LINDSEY HILL

PDD Standards Book

Draft Filename: PDD Package 2018.08.24

Commented [VA1]: Staff Mark-up 9.7.18

Figure 1-1: ~~Ground Level~~ Layout of Land Uses at Lindsey Hill.

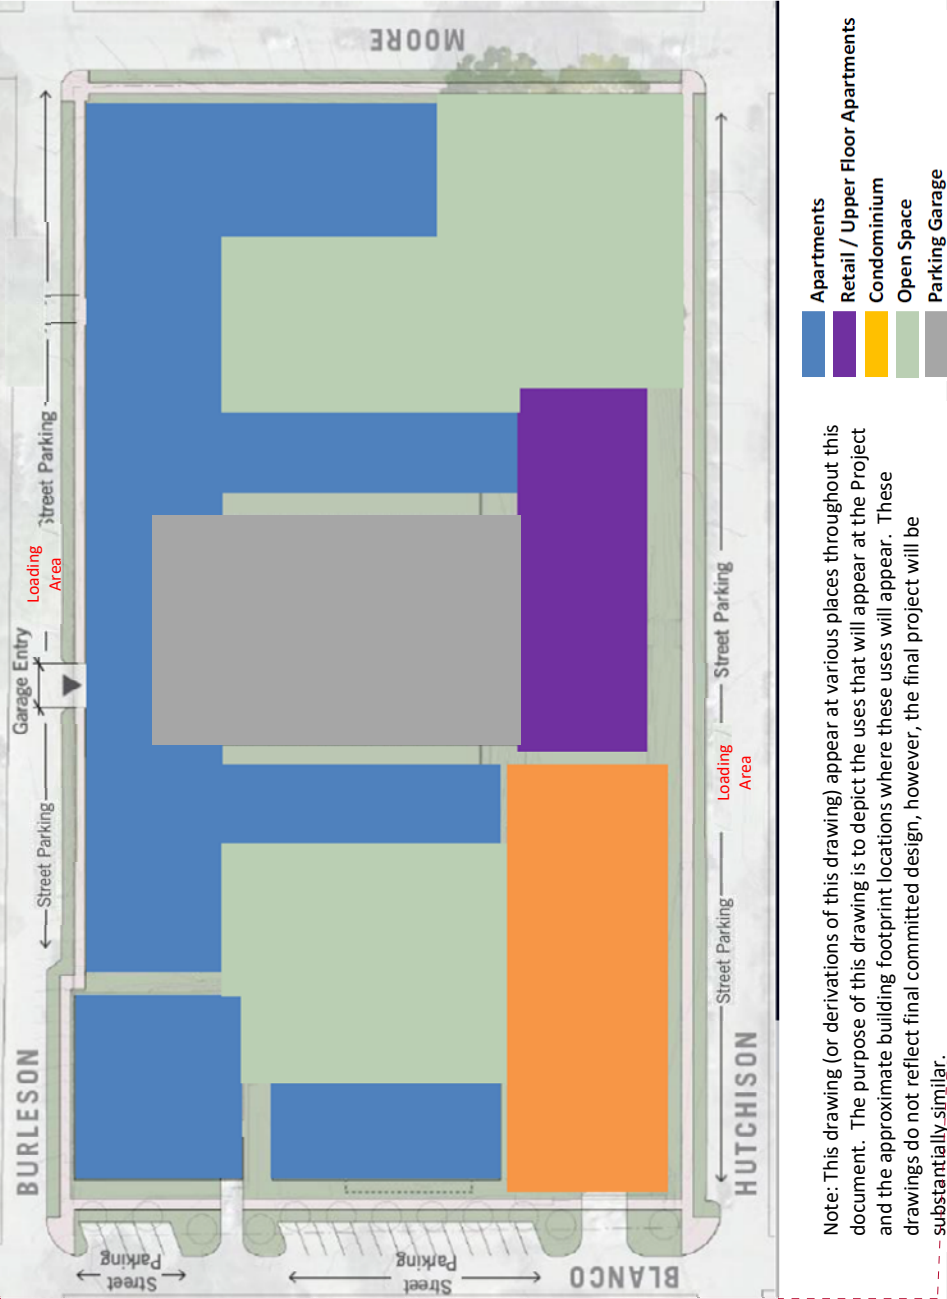
Commented [VA5]: Depict the location of the office space on figure 1-1. Recommend using a cross-hatch symbol on top of the existing colors on the concept plan. Include this cross hatch as a line item in the legend so that we understand that office space may be allowed in these areas.

Commented [VA8]: Edits to Concept Plan:
-The on-street parking, garage entry, loading area, street parking, etc need to be removed. This will be shown more effectively through another exhibit later in the document.
- For consistency, terminology should match that on the previous page.
- Please differentiate between public and private open space.

Commented [VA12]: Depict the location of the office space on figure 1-1. Recommend using a cross-hatch symbol on top of the existing colors on the concept plan. Include this cross hatch as a line item in the legend so that we understand that office space may be allowed in these areas.

Figure 1-3: Phasing plan depiction. Project sections that may be completed during either Phase 1 or Phase 2 are labeled Option 1 and Option 2.

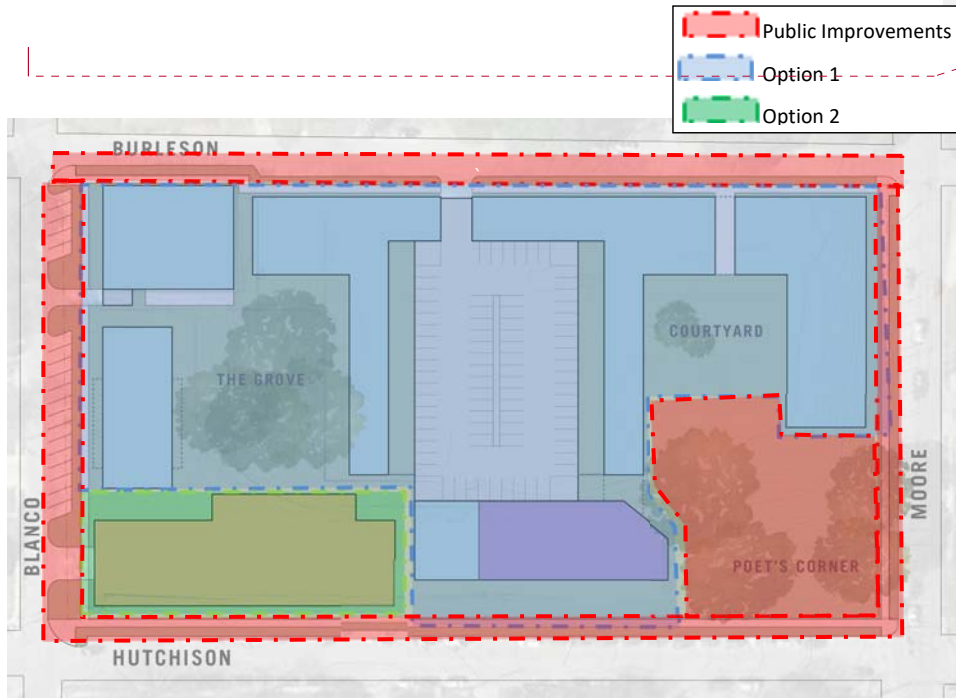
Commented [VA13]: Staff recommendation: use the basic concept plan, Figure 1.1, as the underlying image here and then add the overlays

Figure 4-5: Blanco Street streetscape design.

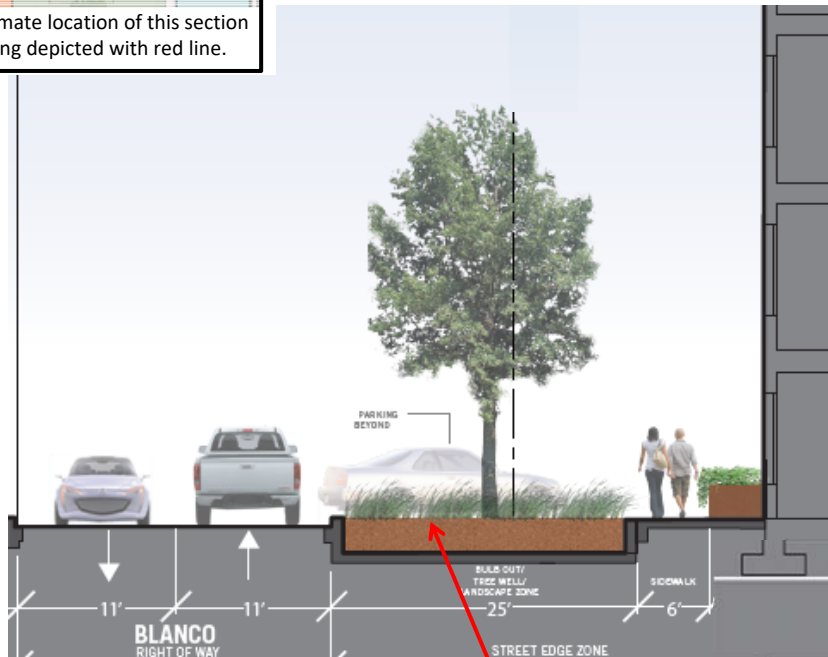
Commented [VA34]: This section requires re-reviewed by the Fire Department.

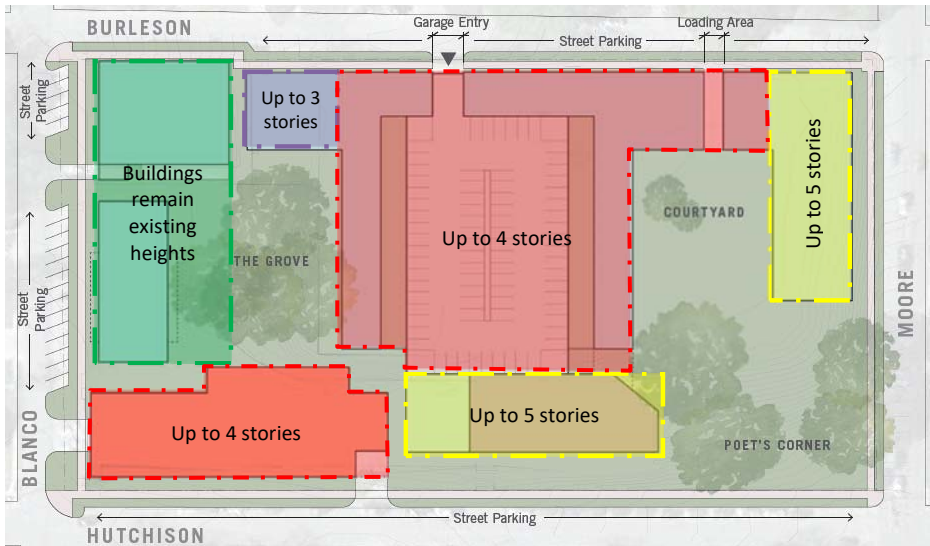
Commented [VA37]: The concept plan image needs to be utilized here (Figure 1-1) with building height overlays on top.
